**FINAL DRAINAGE REPORT
FOR
STERLING RANCH FILING NO. 5**

Project No. 25188.16

PCD Filing No: XX-XXX ← SF241

STERLING RANCH FILING 5
EXISTING DRAINAGE MAP
JOB NO. 25188.16
11/03/23
SHEET 1 OF 1

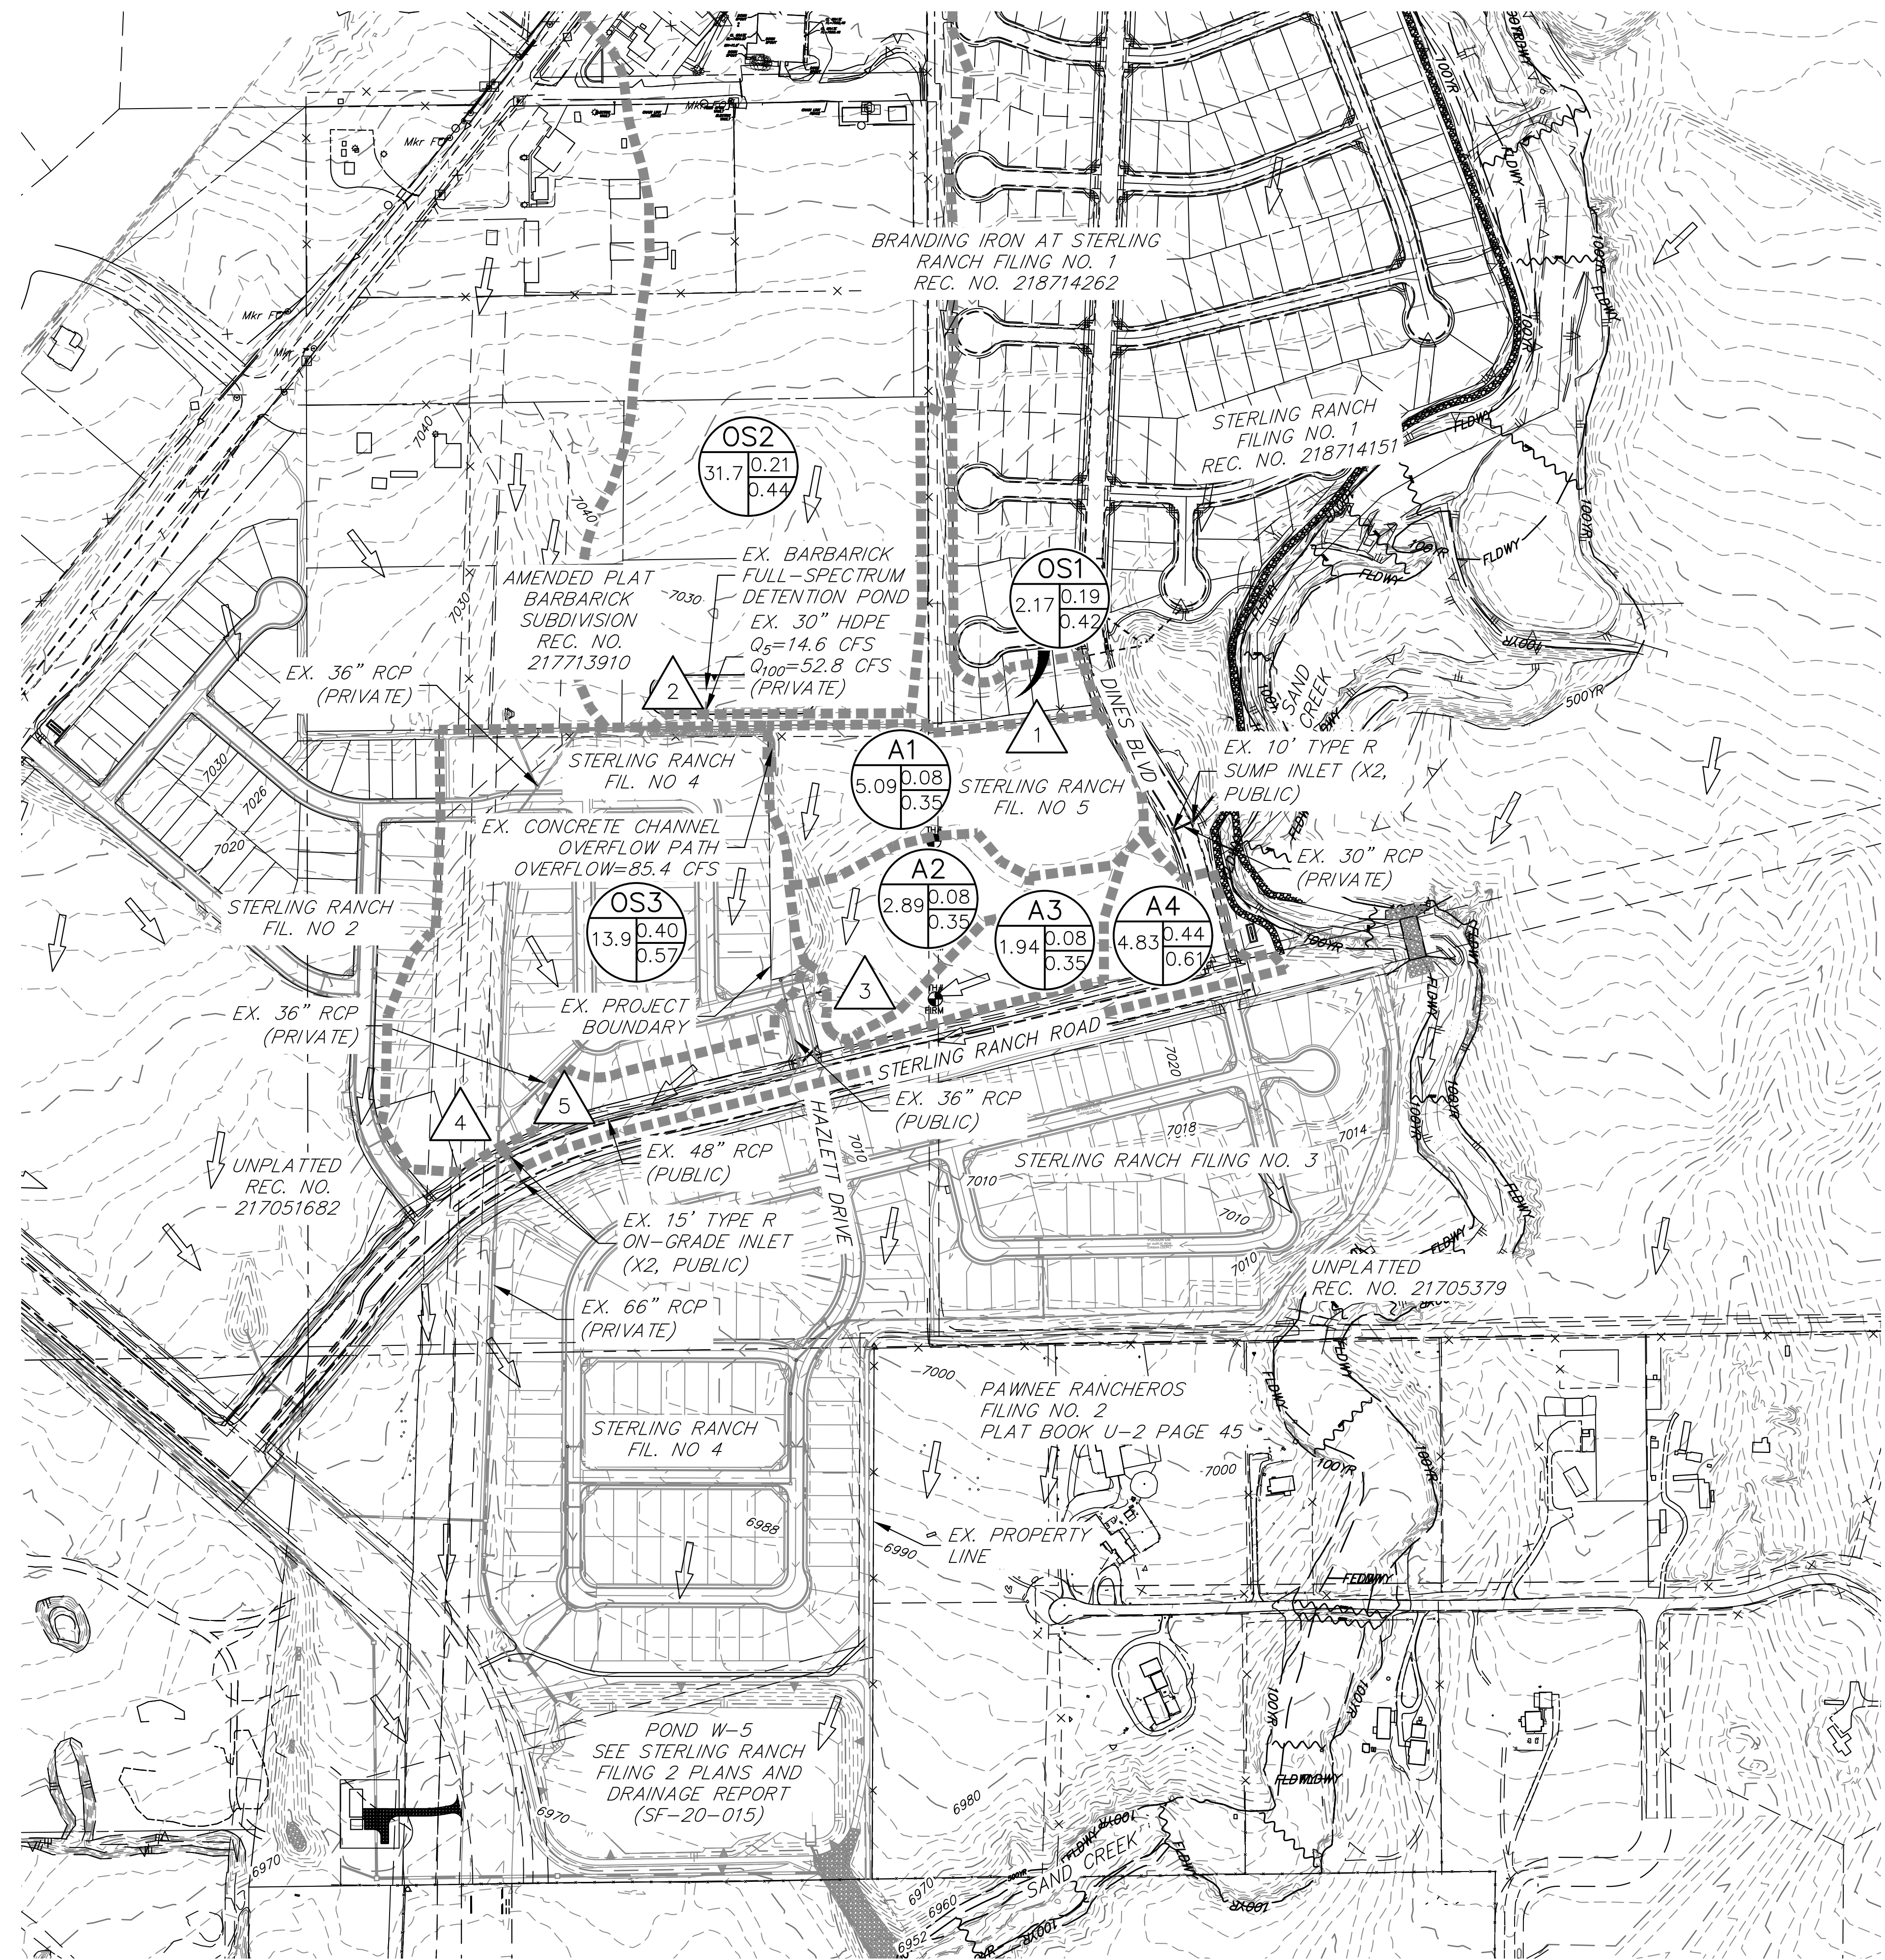
Add note to see existing drainage map for extents of offsite basins

STERLING RANCH FILING NO. 5
 PROPOSED DRAINAGE MAP
 JOB NO. 25188.16
 12/20/23
 SHEET 1 OF 1

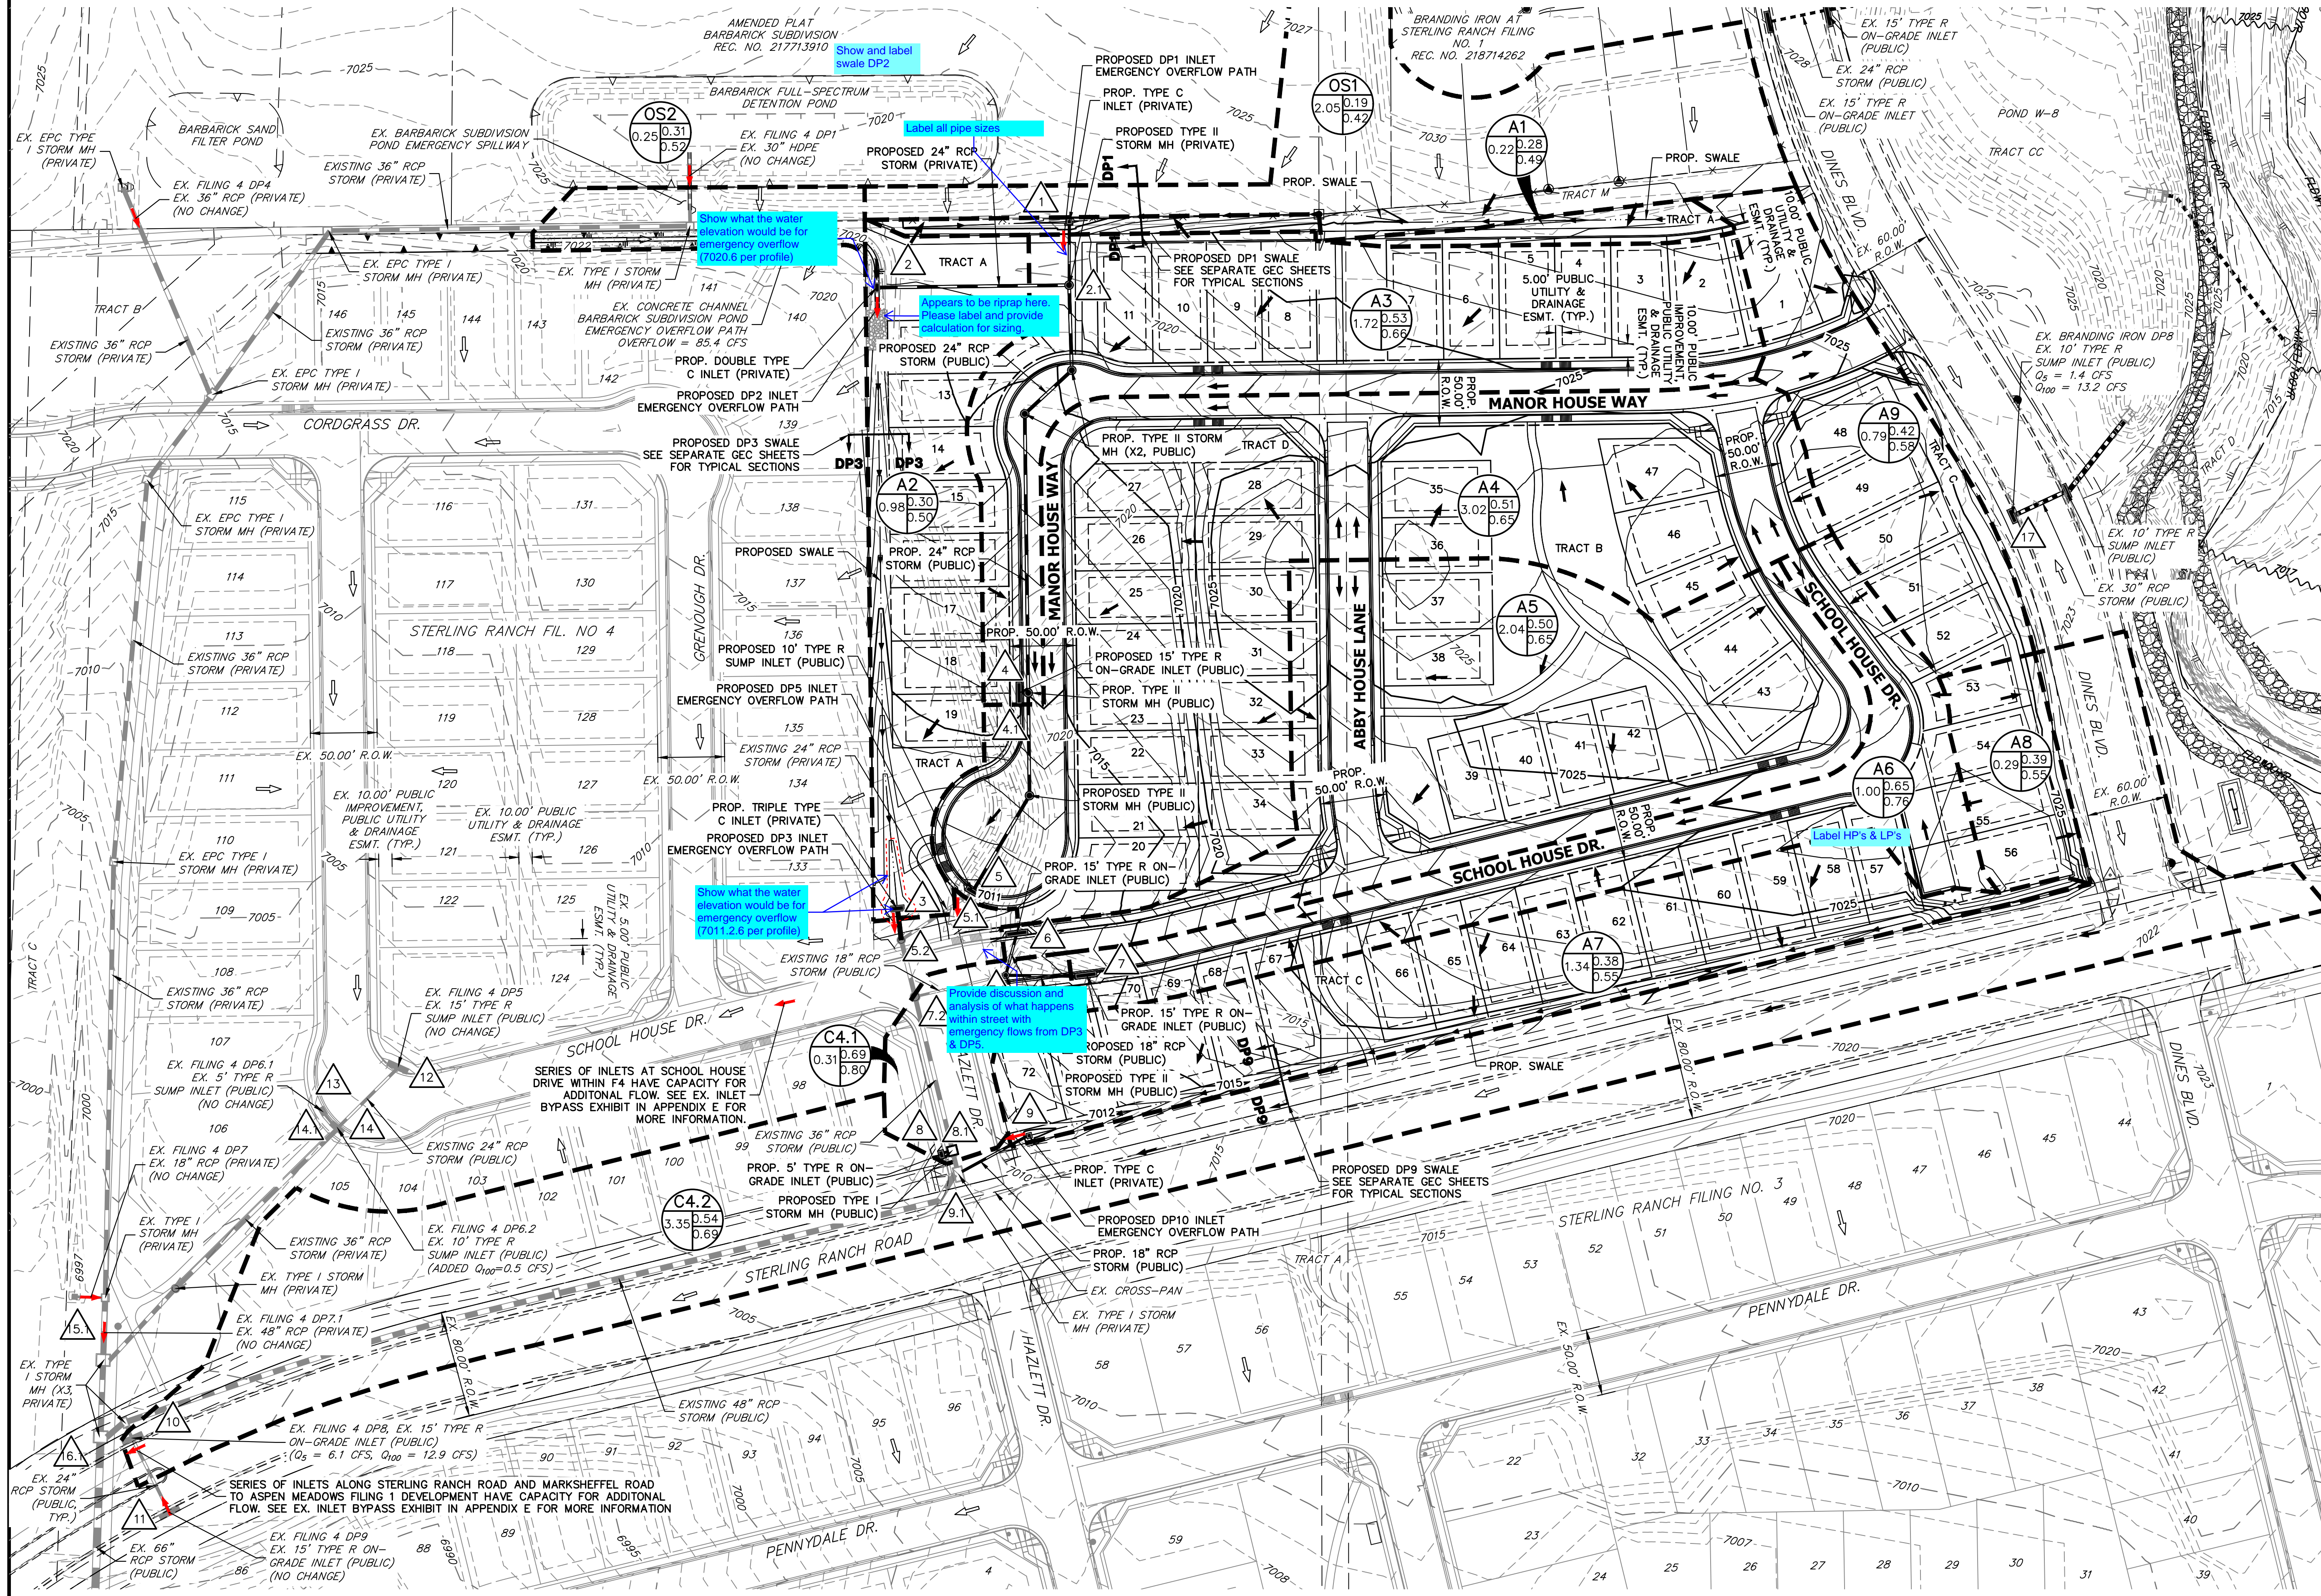
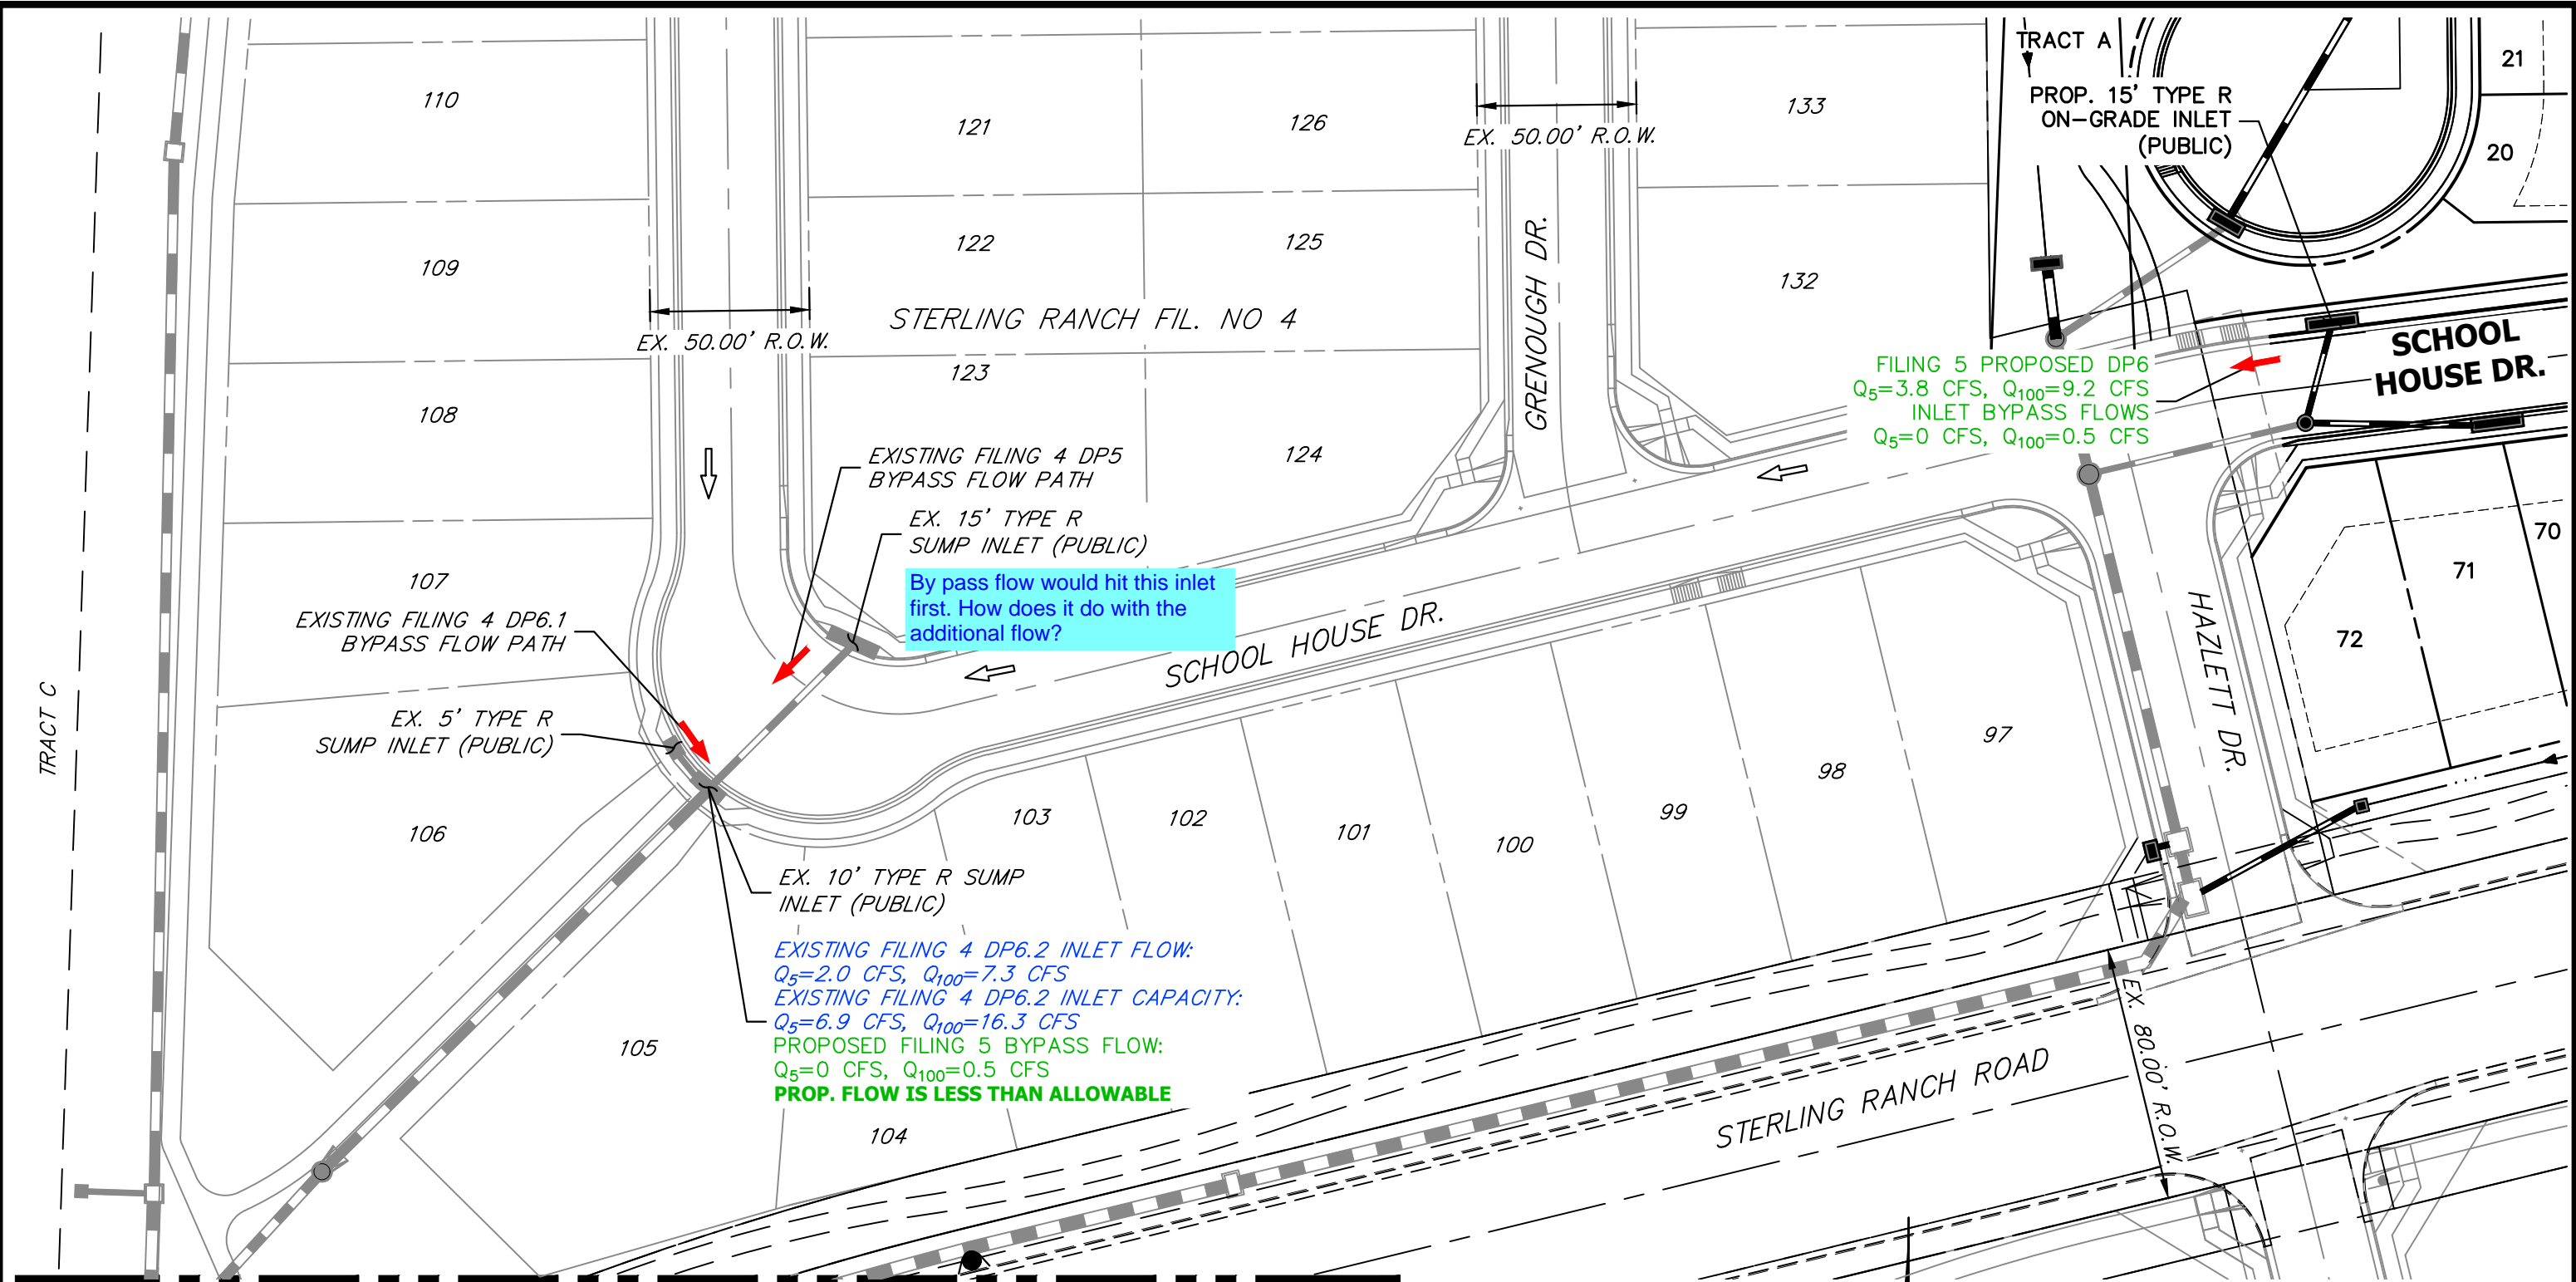
Appears to be wrap here. Please label and provide calculation for sizing.

Show what the water elevation would be for emergency overflow (7011.2.6 per profile)
